Attachment C: Public Comments Received on the
Draft Initial Study/ Mitigated Negative
Declaration

Re: Guadalupe River Bridge Replacement Project – Draft Initial Study/Mitigated Negative Declaration (IS/MND)

Comment Letter B

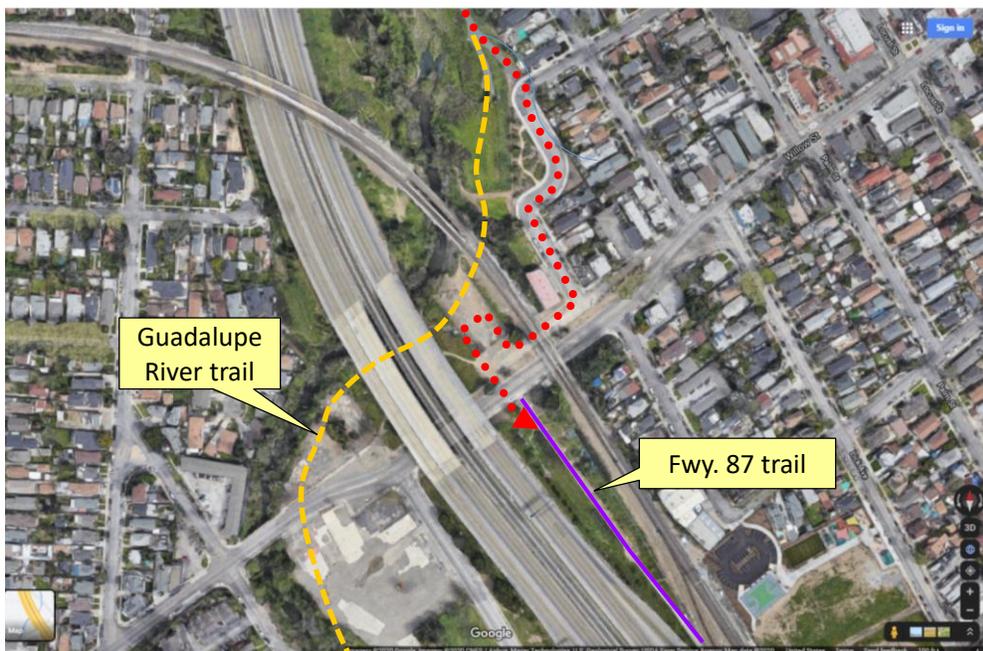
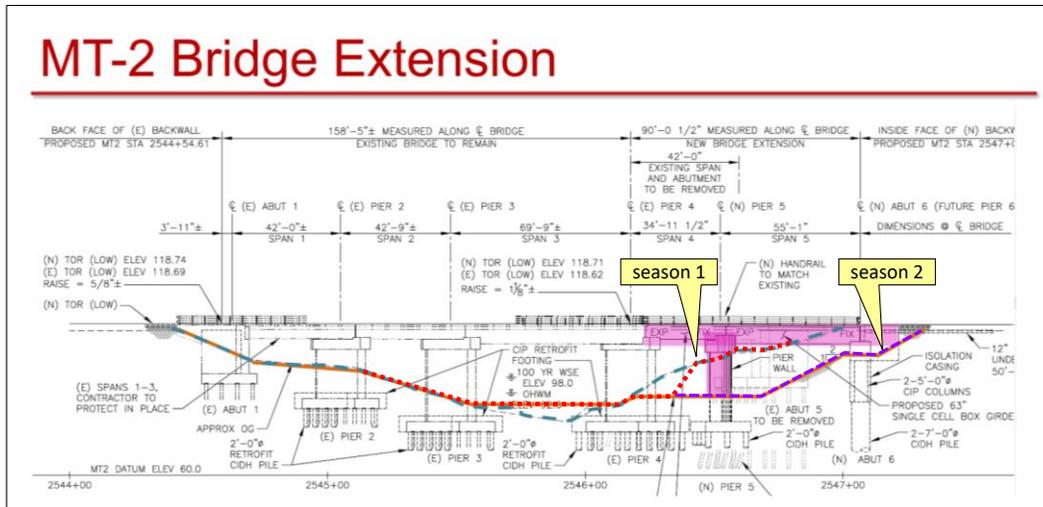
One alternative: why not replace MT-1 with a double track bridge? I appreciate that the plan here is to extend MT-2 rather than replace it, and thus it is not practical to add a second track to that bridge, but MT-1 is a completely new bridge which readily could be made wider. Double the tracks on MT-1 now when there's the opportunity, and then the river will not need to be dewatered for a third season in order to construct the needed third bridge, and thus environmental damage can be reduced.

B-5

I appreciate that there might be issues related to the ownership and operation of a double-wide bridge, with one track on a double-wide MT-1 run by Union Pacific while the other track is run by Caltrain. However, this issue has arisen before and been solved, as illustrated by the new bridges over the Los Gatos Creek, just a mile down-track. There too the bridges were replaced, first one and then the other, but the old single-track eastern bridge was replaced with the double-track bridge now in service, with freight on one track and passenger service on the other.

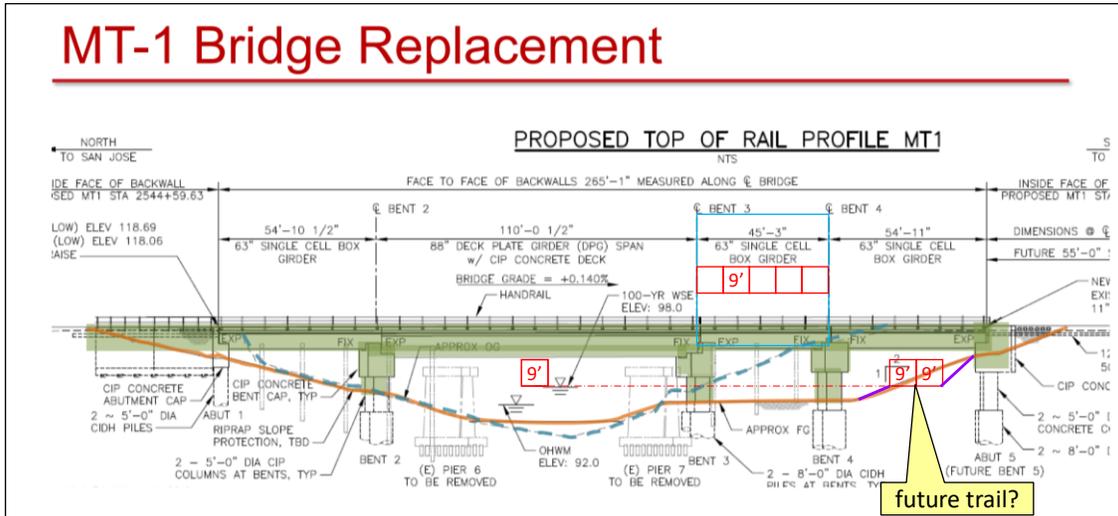
And is it even necessary to dewater the river for two seasons? Could the in-channel grading for MT-2 be done while the river is dewatered for the construction of MT-1, without disrupting train service on MT-2, as shown by the dotted red line below? Then, during the second season when MT-2 is being extended, all of the remaining grading (purple dashed line) would be outside of the river channel and thus wouldn't require a second river dewatering.

B-7

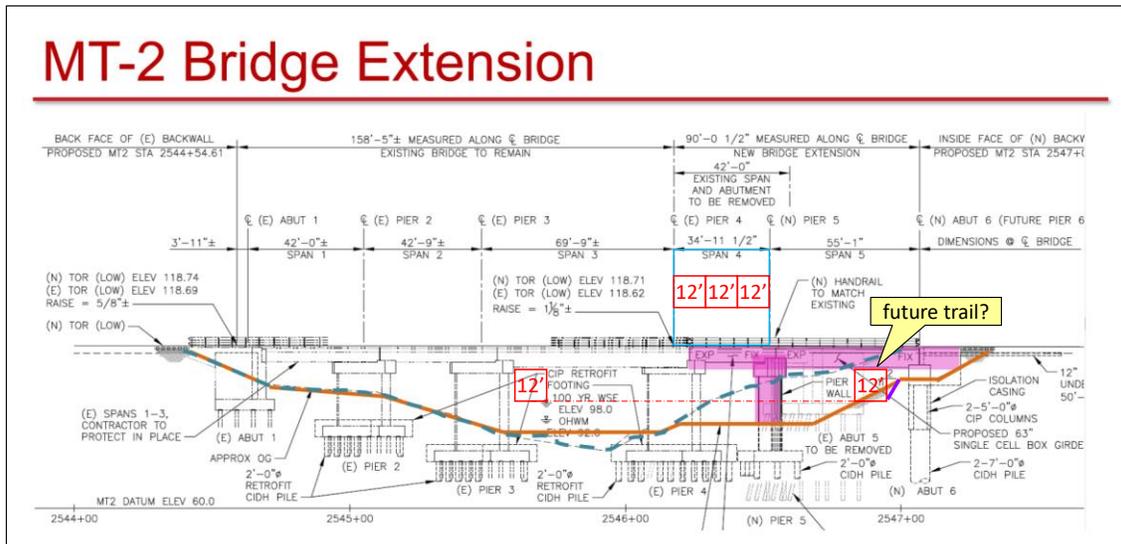
Utilizing an analytical technique from my aerospace past, it appears to me that it would be quite feasible to grade a "bench" between Bents 4 and 5 on MT-1 that is outside even the channel of a 100-year flow and still have in excess of 9' vertical clearance. (Analysis method: the blue box in the diagram matches

the feature that is dimensioned as 45'3"; scale it by 20% to get a 9' box, and copy that box onto the 100-Yr WSE ("water surface elevation") mark to check vertical clearance. Of course, a more thorough analysis is needed to verify and refine these PowerPoint studies.)

For the extension of MT-2, it looks like it would be possible to have nearly 12' of vertical clearance outside the 100-year flood zone, passing between Pier 5 and Abutment 6.

It would appear to require a trivial amount of grading to go from the "approx. FG" ("future grade", in the orange-brown line) to what I'm proposing (the purple line by the red box). If this possible future trail alignment is not precluded by the Caltrain construction, then trail advocates in the community can discuss further details with Valley Water as they design their next projects in this reach.
